From: [Kalyanam, Kaly](#)
To: [CLARK, ROBERT W](#)
Subject: RAI for the Request to use of Alternate ASME Code Case N-770-1 Baseline Examination, Request for Alternative ANO2-ISI-007. (TAC No. ME7646)
Date: Tuesday, August 28, 2012 11:55:00 AM
Attachments: [RAI fro EPNB RAI 08-21-12.pdf](#)

OFFICE OF NUCLEAR REACTOR REGULATION
REQUEST FOR ADDITIONAL INFORMATION
USE OF ALTERNATE ASME CODE CASE N-770-1 BASELINE EXAMINATION
ENTERGY OPERATIONS, INC
ARKANSAS NUCLEAR ONE, UNIT 2
DOCKET NUMBER 50-368

Figure 1 Top View of 2D Matrix Array Depicting Separation Dimension

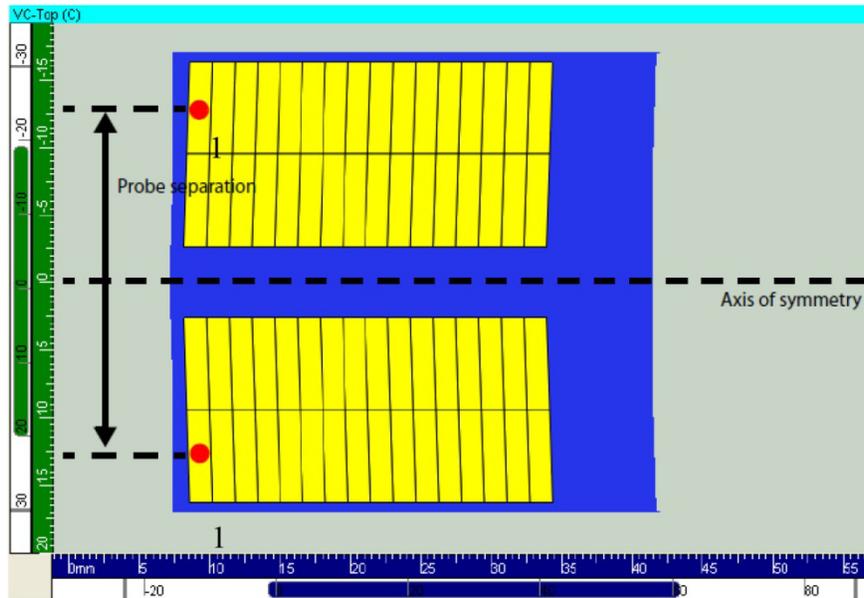
- 2. Longitudinal (L) and/or shear (S) wave
 - iii. Array configuration (matrix)
 - 1. Whether identical or different transmit-receive arrays, if used
 - 2. Physical separation between arrays (if TRL/TRS configuration). Identify distance between first element of one array and first element of second array (array separation – see Figure 1)

Figure 2 Top View of 2D Matrix Array Depicting Primary and Secondary Axis Pitch Dimensions

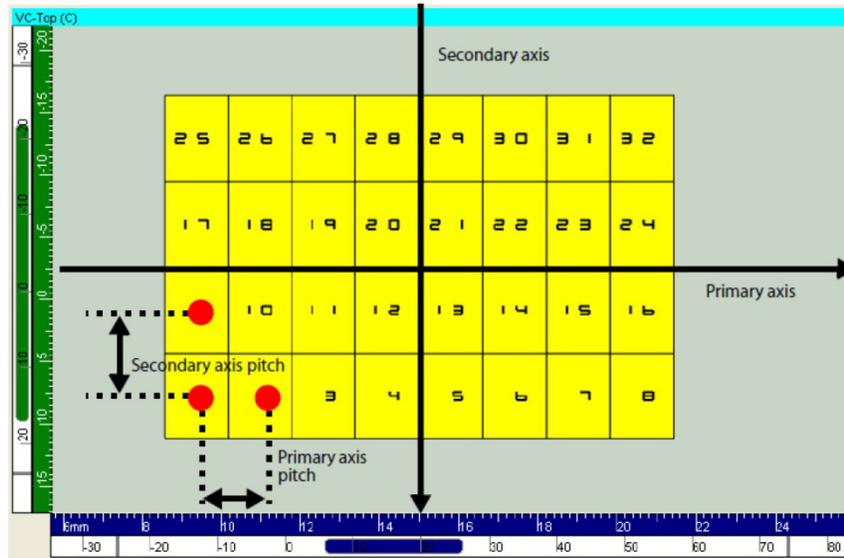
- 2. Number of elements along the secondary axis
 - v. Element dimensions along primary and secondary axes, spacing between elements, and center-to-center distance (pitch – see Figure 2)

Figure 3 Definition of Wedge Angle

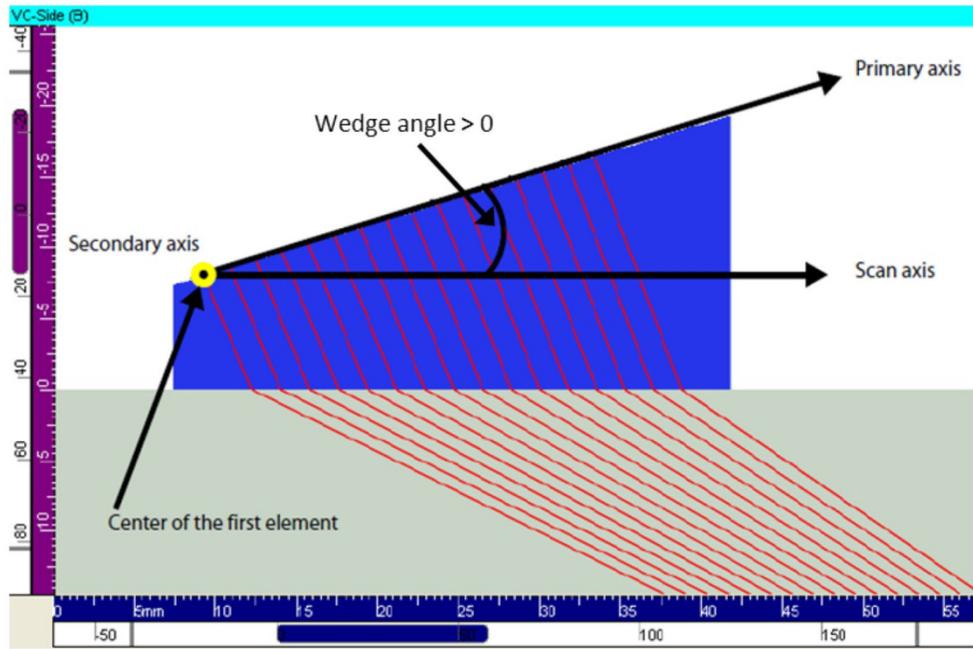
- b. Wedge (see Figure 3)
 - i. Material type – Rexolite, other, etc.

1. Longitudinal and shear wave velocity
 2. Attenuation (if known)
 3. Density (if known)
- ii. Geometry
1. Wedge angle
 2. Roof angle (if used)
 3. All physical dimensions necessary to create 3-D solid model, such as height at front of wedge, height at back of wedge, width of wedge, and length of wedge

4. Placement of each probe on each wedge; i.e., what is the height of the middle of the first element?
 5. Is wedge contact geometry contoured to the specimen? If not, what contour does it have, if any?

Figure 4 Beam Focusing Options for Phased Array Probes

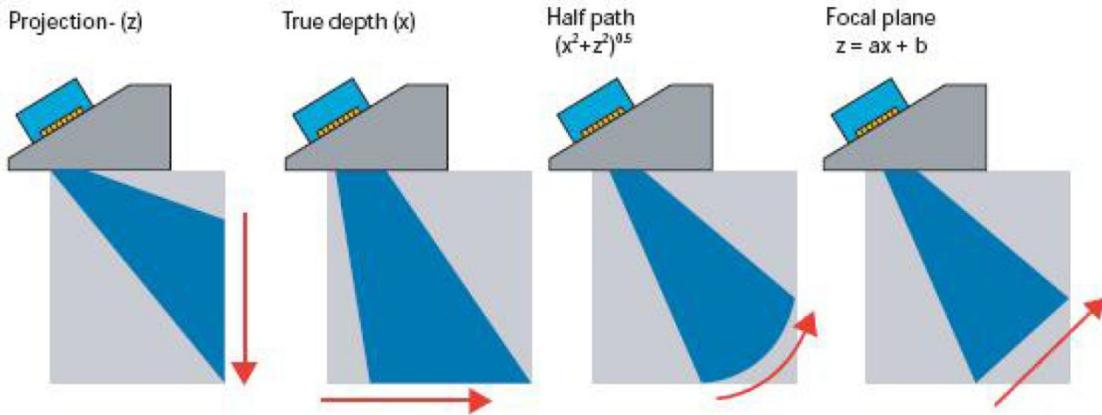
- c. Beam focusing
- i. Please state the type of focusing used and include associated details, as listed below. The four types of focusing techniques are listed below and shown graphically in Figure 4.

1. *Projection* – focusing in a specific vertical plane
 - a. Parameters: distance from probe reference point, sweep angles (start, stop, interval), skew angle(s)

2. *True depth* – focusing at specific constant depth with all angles focused at this depth
 - a. Parameters: focusing depth, sweep angles (start, stop, interval), skew angle(s)

3. *Half-path* – sound path held constant as beam is swept
 - a. Parameters: sound path length, sweep angles (start, stop, interval), skew angle(s)
 4. *Focal plane* – arbitrary user-defined plane of focus

- a. Low angle path length, high angle path length, sweep angles (start, stop, interval), skew angle(s)
 - ii. Number and configuration of elements used in data acquisition (active aperture), if different than total number of elements within each probe (e.g., if a linear array probe physically contains 64 elements but only the first 32 were active – this needs to be defined)
